INITIAL FIRE SAFETY INSPECTION REPORT

Futex Bangladesh Garment Manufacturing Co., Ltd.

RSC ID: 26130

Date: 03-Feb-2025

Table-1: Shed-1

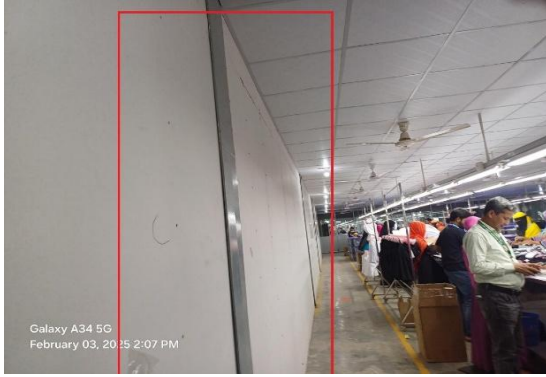
Sl No.	Category	Findings	Required Action	Remediation Time Frame
F-1	Fire Rated Construction	The Shed-1 was constructed at 2018-19. The construction type is unprotected steel construction. As per RSC Technical Guideline and BNBC 2006, The Fire rating of the structure requires to be confirmed as per BNBC 2006. The "Ministry of Housing and Public Works" has issued a resolution based on the recommendations from the House Building Research Institute (HBRI) and the Public Works Department (PWD) to assess structural fire protection requirements of steel buildings (unprotected non-combustible construction type) according to BNBC 2020. Fire Resistance Ratings of Exterior Walls is not maintaining considering the Fire Separation Distance.	The construction type shall confirm to be in accordance with BNBC 2020 Part-3, Table 3.1.7. Ensure fire resistive rated construction following Table 3.3.1 (a) Part 3 Section-3, Table 3.2.2 and Table 3.2.3 Part 3 Section 2 and Table 4.1.1 from BNBC 2020 Part 4 Section 1. Provide design philosophy to determine the construction type as per BNBC 2020. If any construction rating requires, Consult a qualified fire protection engineer to achieve the require fire rating.	Within 6 months

F-2	Means of Egress	The maximum travel distance exceeds 45 m at production occupancy (G2) and 30 m at finished goods warehouse which is not meet Section 6.13 of RSC Technical Guidelines (Standard). Location: Shed-1	Reconfigure the egress arrangement or provide additional exits so that the travel distance shall not exceed 45 m for G2 and 30 m for H2. or, Provide a standpipe system in accordance with the RSC Technical Guidelines (Standard) along with the automatic fire detection system, and portable fire extinguishers to increase the travel distance limitations for G2 (RMG factories) to 60 m (200 ft). or, Provide a complete automatic sprinkler system in accordance with the RSC Technical Guidelines (Standard) along with the automatic fire alarm system, and portable fire extinguishers to increase the travel distance limitations for G2 (RMG factories) to 122 m (400 ft).	Within 3 months
-----	-----------------	---	---	-----------------

F-3	Fire Rated Construction	The east exit discharge path of Shed-1 was not fire separated with Shed-2. The egress court was not fire rated. The egress court has unprotected openings within 10 ft height.	An egress court serving as a portion of the exit discharge shall be open to the sky or provided with a fire resistance rated enclosure the same as the exit enclosure. Egress courts less than 3050 mm (10 ft) in width (as measured from the building and the adjacent property line) shall be provided with walls having a 1-hr fire resistance rated construction for a distance of 3050 mm (10 ft) above the floor of the court.	Within 3 months

F-4	Fire Rated Construction	Rooms used for storage of combustible materials are not separated due to non rated board partition from the packing section at Shed-1.	Rooms used for storage of combustible materials shall be separated from the surrounding occupancy with a minimum 1 hour construction in accordance with section 3.4.2.1.5 of RSC Technical Guideline (Standard)	Within 3 months

F-5	Means of Egress	Abrupt changes in the elevation of walking surfaces were observed, not meeting the RSC Technical Guidelines (Standard) ¹ V1.0 Section 6.3.4. Location: Shed-1	Abrupt changes in elevation of walking surfaces shall not exceed ¼ in. unless provided with a beveled slope of 1 in 2 that do not exceed ½ in. Changes greater than ½ in. shall meet the requirements for RSC Technical Guidelines (Standard) ¹ V1.0 Section 6.3.5.	Within 3 months

Table-2: Shed-2 & other sheds

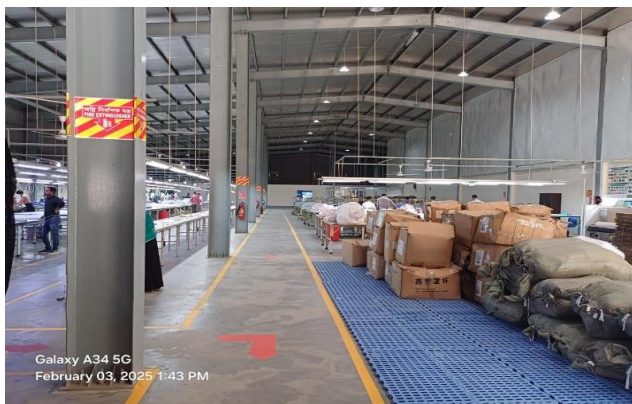
Sl No.	Category	Findings	Required Action	Remediation Time Frame
F-1	Fire Rated Construction	The Shed-2 was constructed at 2018-19. The construction type is unprotected steel construction. As per RSC Technical Guideline and BNBC 2006, The Fire rating of the structure requires to be confirmed as per BNBC 2006. The "Ministry of Housing and Public Works" has issued a resolution based on the recommendations from the House Building Research Institute (HBRI) and the Public Works Department (PWD) to assess structural fire protection requirements of steel buildings (unprotected non-combustible construction type) according to BNBC 2020. Fire Resistance Ratings of Exterior Walls is not maintaining considering the Fire Separation Distance.	The construction type shall confirm to be in accordance with BNBC 2020 Part-3, Table 3.1.7. Ensure fire resistive rated construction following Table 3.3.1 (a) Part 3 Section-3, Table 3.2.2 and Table 3.2.3 Part 3 Section 2 and Table 4.1.1 from BNBC 2020 Part 4 Section 1. Provide design philosophy to determine the construction type as per BNBC 2020. If any construction rating requires, Consult a qualified fire protection engineer to achieve the require fire rating.	Within 6 months

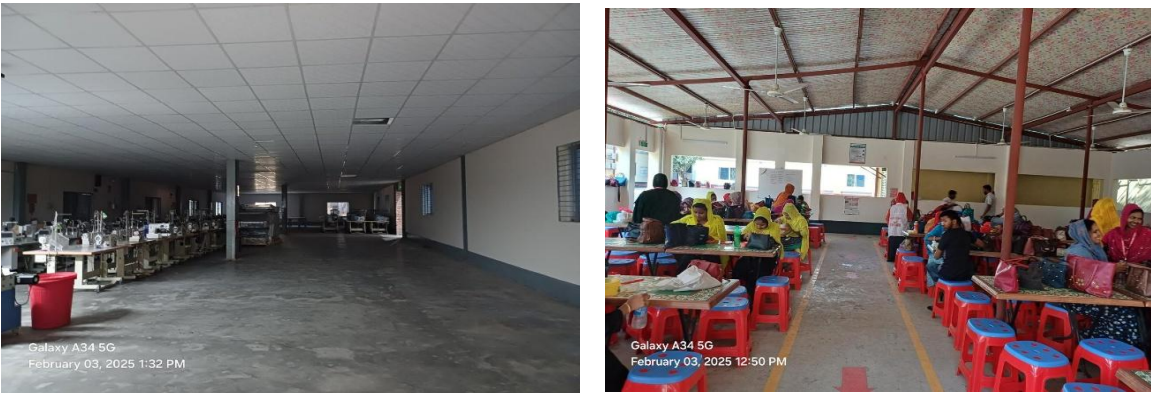
F-2	Fire Rated Construction	The east side exit discharge path was not fire separated with Utility building and west side exit discharge path was not separated from Shed-1. The egress court was not fire rated. The egress court has unprotected openings within 10 ft height.	An egress court serving as a portion of the exit discharge shall be open to the sky or provided with a fire resistance rated enclosure the same as the exit enclosure. Egress courts less than 3050 mm (10 ft) in width (as measured from the building and the adjacent property line) shall be provided with walls having a 1-hr fire resistance rated construction for a distance of 3050 mm (10 ft) above the floor of the court.	Within 3 months
